Access Compliance Report Public Rights-of-Way (Curb Ramps)

Main Street: N/A Cross Street: NARROW_CANYON_RD Location: SE

ADA ID: RPRK211115130711 Ramp Type: Type 4 - Parallel Initial Pass/Fail: Fail Overall Compliance: No Severity Score: 30

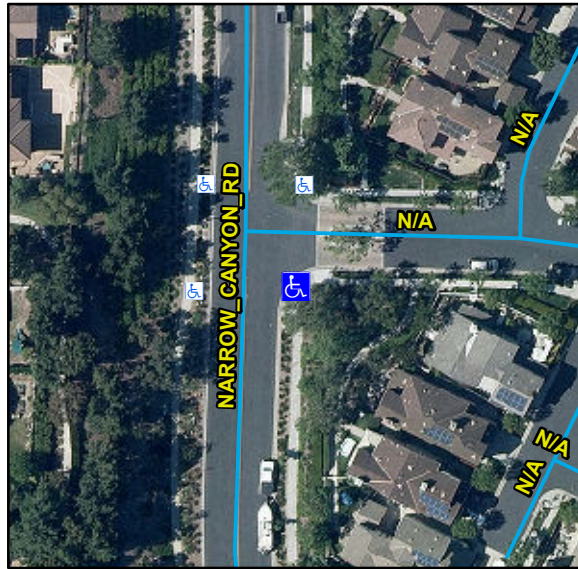
Compliance	Description	Data	Compliance	Description	Data
N/A	Ramp Length LT (in)	123	N/A	Ramp Length RT (in)	131
Yes	Ramp Width LT (in)	89	Yes	Ramp Width RT (in)	89
No	Ramp Run Slope LT (%)	12.3	Yes	Ramp Run Slope RT (%)	3
Yes	Ramp Cross Slope LT (%)	0.4	Yes	Ramp Cross Slope RT (%)	1.4
N/A	Landing Present	N/A	N/A	DWS Provided	N/A
N/A	Landing Length (in)	N/A	N/A	DWS Contrast	N/A
N/A	Landing Width (in)	N/A	N/A	DWS Length (in)	N/A
N/A	Landing Run Slope (%)	N/A	N/A	DWS Full Width	N/A
N/A	Landing Cross Slope (%)	N/A		DWS Offset Type	N/A
N/A	Landing Movement Obstructed?	N/A	N/A	DWS Offset Left (in)	N/A
	Landing Movement Type	N/A	N/A	DWS Offset Right (in)	N/A
N/A	Landing Shared	N/A			
N/A	Clear Space	Yes			
N/A	Clear Space To Crosswalk (in)	N/A			
N/A	Marked Crosswalk 1	No	N/A	Marked Crosswalk 2	No
	Crossing 1 Direction	N		Crossing 2 Direction	W
	Marked Crosswalk 1 Width (in)	N/A		Marked Crosswalk 2 Width (in)	N/A

Remove & Replace Curb Ramp With Two New Directional Ramps or Equivalent.
